FIRE SAFETY INSPECTION REPORT

MB Knit Fashion Ltd.

ACCORD ID: 12502

**Inspected By: Nusrat Hossain Trisha, Md. Sabbir Ahmed Shourav
Date: 06 September, 2016**

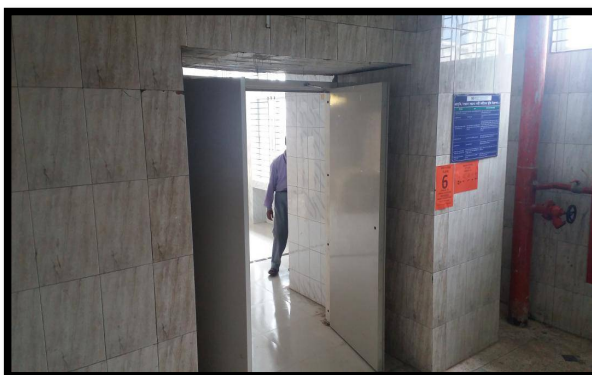
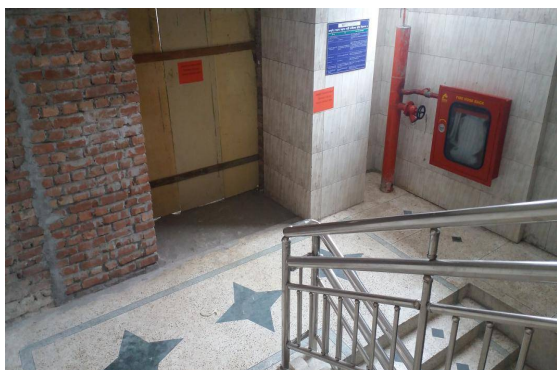
F-3	Fire Rated Construction	The north & south exit stairs are not fully separated from [work areas, other spaces] on each floor by fire-rated construction in some floors. Fire door installation is in progress.	Stairs shall be enclosed with a minimum 2-hr fire-rated construction. Seal all unprotected openings and provide minimum 1.5-hr fire rated doors to separate the exit stairs from work areas and other building spaces on all floor levels. Ensure that the fire doors are self-closing, positive latching and that they are provided with fire exit (panic) hardware where serving production floors.	Within 3 months
-----	-------------------------	---	---	-----------------

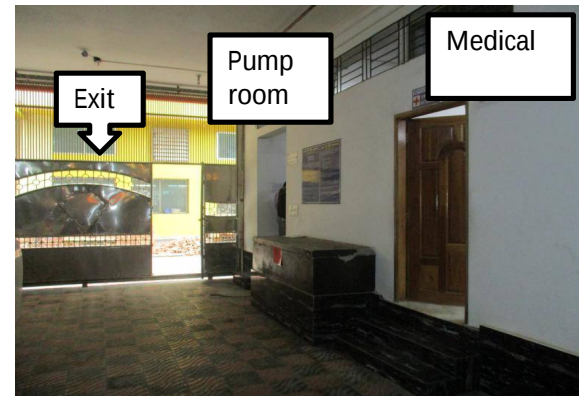
F-5	Fire Rated Construction	Pump room is not properly fire separated from the exit passageway by fire rated construction. (Location: Ground floor beside the medical centre)	Separate the pump room by a minimum 2-hr fire-rated construction to separate it from the exit passageway. Seal and/or protect all openings to maintain the required fire separations. Provide proper ventilation and consult a qualified engineer.	Within 3 months
-----	-------------------------	--	--	-----------------

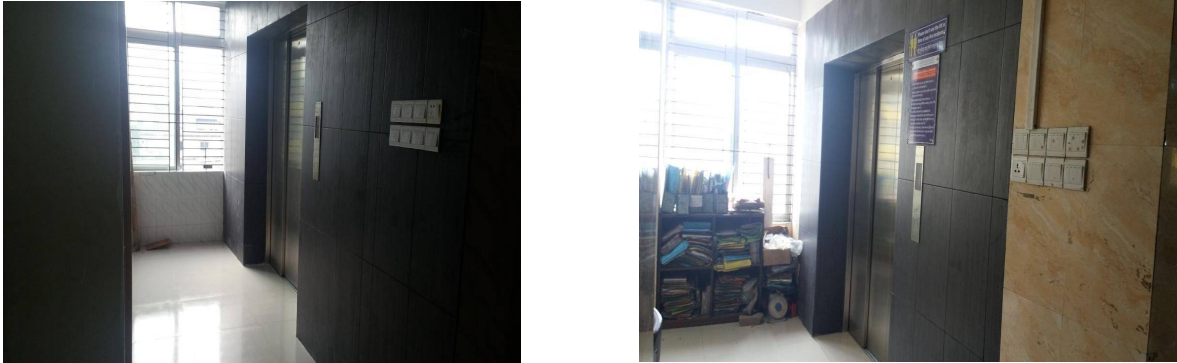
F-6	Fire Rated Construction	Elevator shaft is not separated from the production floor by proper fire rated construction (openings, non-rated doors)	Provide a minimum 2-hr fire rated elevator shaft to separate it from each floor. Seal and/or protect all openings to maintain fire separation.	Within 3 months

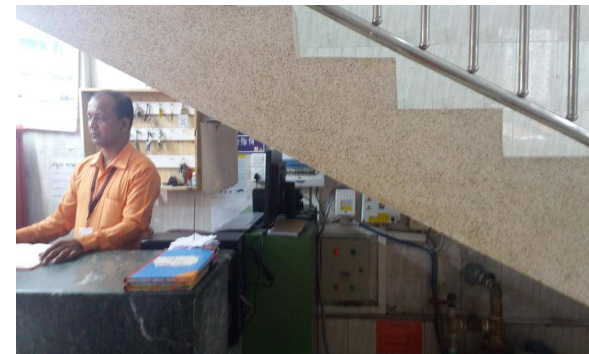
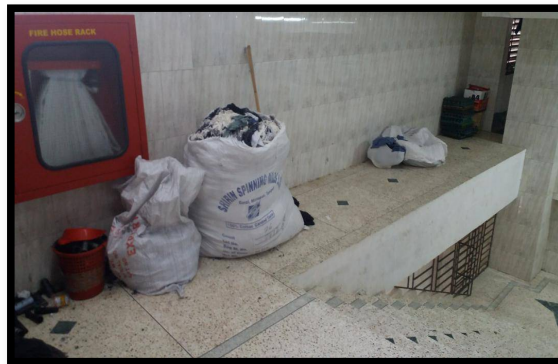
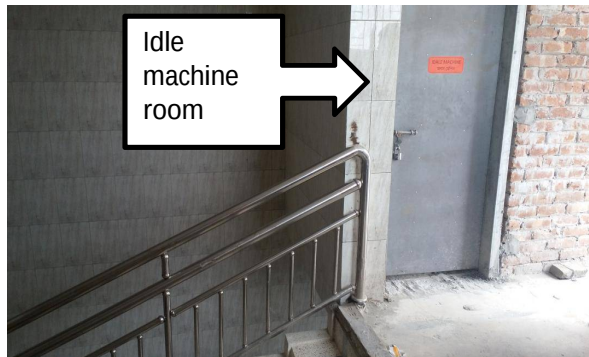
F-7	Egress	Storage was located in the exit stairwell. (Location: Wastage bag on stair landings of all floors, idle machine room discharges in the staircase at rooftop, reception point, pump panel board at ground under the staircase)	Remove all storage from exit stairs and egress paths.	Immediate

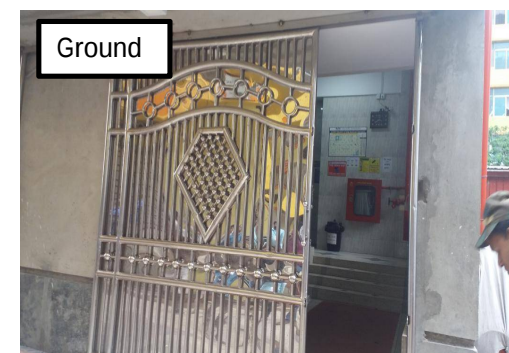
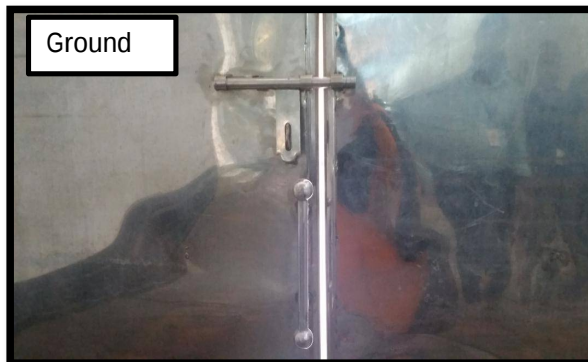
F-8	Egress	Non Compliant doors (sliding doors) are provided at ground floor & rooftop.	Replace all non-compliant doors along the means of egress with side-hinged, swinging egress doors. If locks are required for security reasons, utilize specialized door locking features complying with NFPA 101.	Within 1 month
-----	--------	---	--	----------------

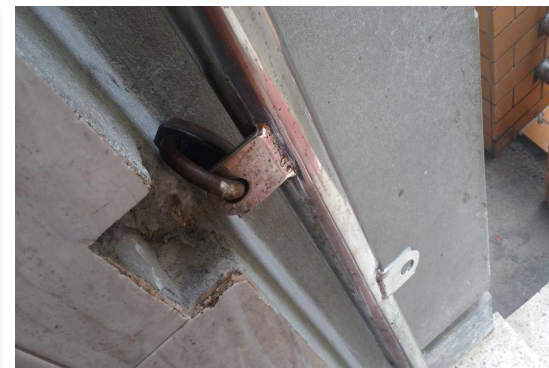
F-9	Egress	Egress doors/gates with locking features not complying with NFPA 101 are provided at rooftop & ground floor.	Remove locking features from all egress doors/gates. If locks are required for security reasons, utilize specialized door locking features complying with NFPA 101.	Immediate
-----	--------	--	---	-----------

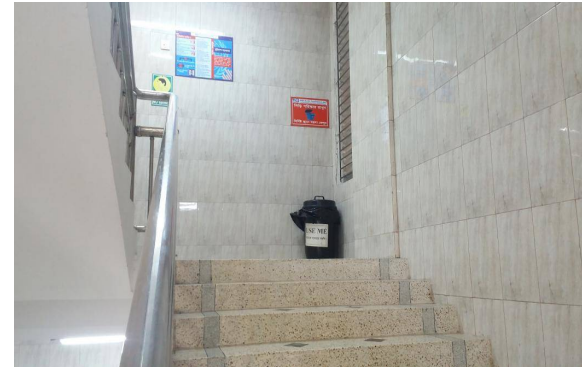
F-10	Egress	Exit capacity is not adequate for the occupant load at 6th floor (Dining, Canteen, Finished Goods Store; Available exit capacity: 342, Present occupant load including dining: 357)	1. Reduce occupant load to not more than available exit capacity. Or 2. Provide additional exits to increase exit capacity.	Immediate
F-11	Egress	Handrails are not provided in both side of the exit stairs.	Provide handrails on both sides of the exit stair. New handrails shall have a minimum height of 865mm (34 in.) and a maximum height of 965 mm (38 in.) as measured from the leading edge of the tread. Intermediate handrails shall be provided when the stair width exceeds 2.2 m (87 in.)	Within 3 months

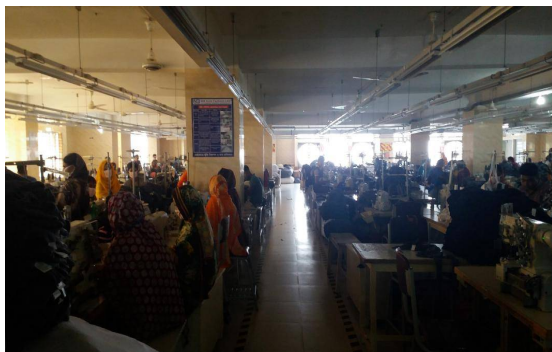
F-18	Egress Lighting	Based on the number and location of emergency lights observed, adequate illumination levels are not anticipated along egress routes. Location: All floors	Test the emergency lighting system on each floor and provide additional emergency fixtures to provide adequate illumination along the means of egress. Provide a minimum illumination of 10 lux at the floor level within exit stairs and exit discharge paths and minimum 2.5 lux along exit access aisles. Illuminated directional signs shall be provided where there is a change in the direction for the path of travel and the direction to an exit is not obvious.	Within 3 months
------	-----------------	---	---	-----------------
